Product Change Notification

E4T – S4T Update – PCN 7192

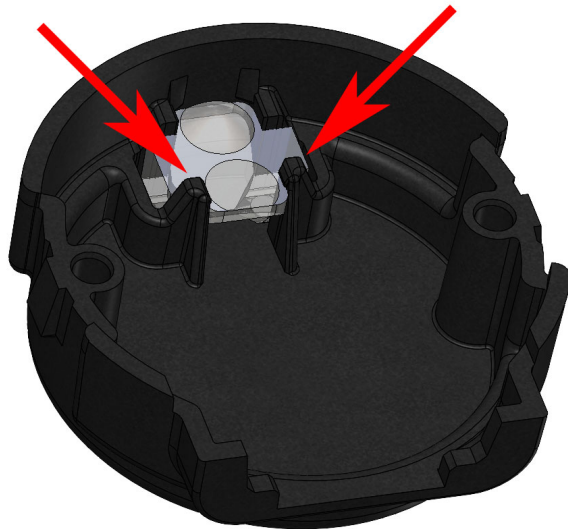
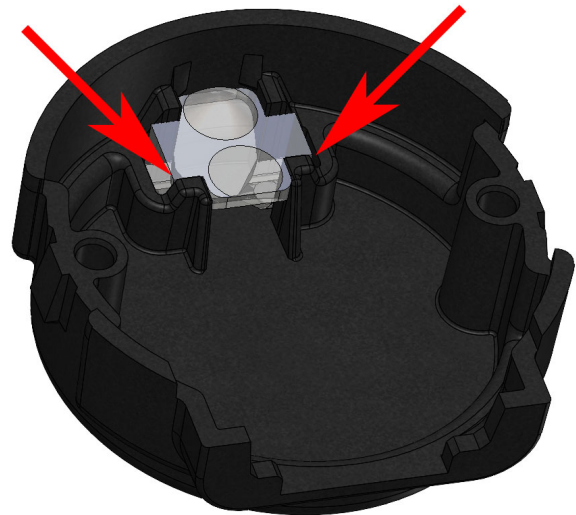
Additionally, we have made a slight modification to the E4T and S4T cover, reduction in height of a small tab, to allow additional clearance.
